UNITED STATES PATENT AND TRADEMARK OFFICE

APPLICATION NO.	FILING DATE	FIRST NAMED INVENTOR	ATTORNEY DOCKET NO.	CONFIRMATION NO.
10/813,863	03/31/2004	Edward Vaquero	P03166	5586
23702	7590	06/06/2007		
Bausch & Lomb Incorporated One Bausch & Lomb Place Rochester, NY 14604-2701			EXAMINER LANG, AMY T	
			ART UNIT 3731	PAPER NUMBER
			MAIL DATE 06/06/2007	DELIVERY MODE PAPER

Office Action Summary

DETAILED ACTION

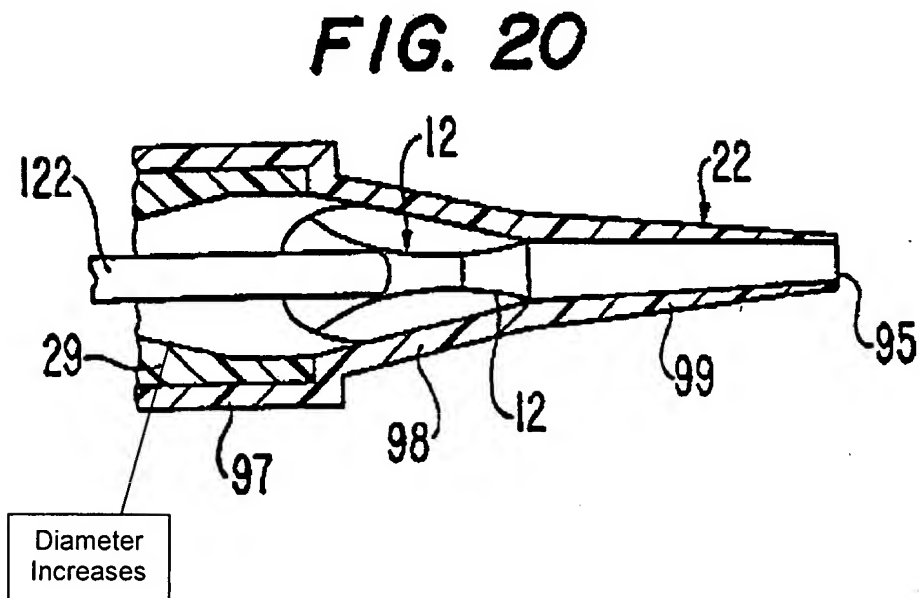
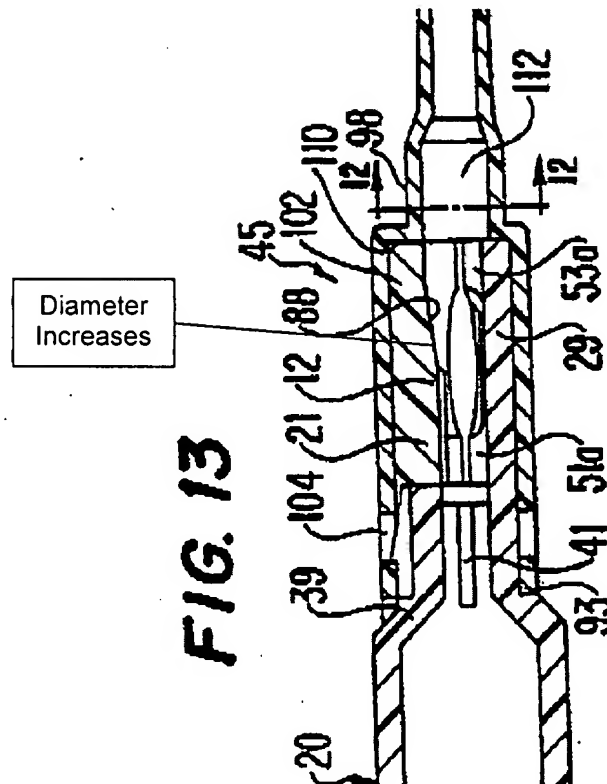
With regard to **claim 1**, Figueroa discloses a device for injecting a foldable IOL into an eye ([0006]). The device comprises body (16) and lumen (24), wherein the lumen terminates in a distal opening (95) (Figure 13). Shelf segment (29) defines an opening in the body between the proximal and distal ends of the device ([0044], [0045],

[0046]). As shown in Figures 13 and 20 below, the lumen increases in diameter toward the distal open tip.

Although only a portion of the lumen of Figueroa increases in diameter toward the distal tip, it is the examiner's position that the instant claims are broad enough that a portion of the lumen overlaps the instant claims.

With regard to **claims 8 and 10**, as shown in Figure 20, the increase of the diameter of the lumen is gradual.
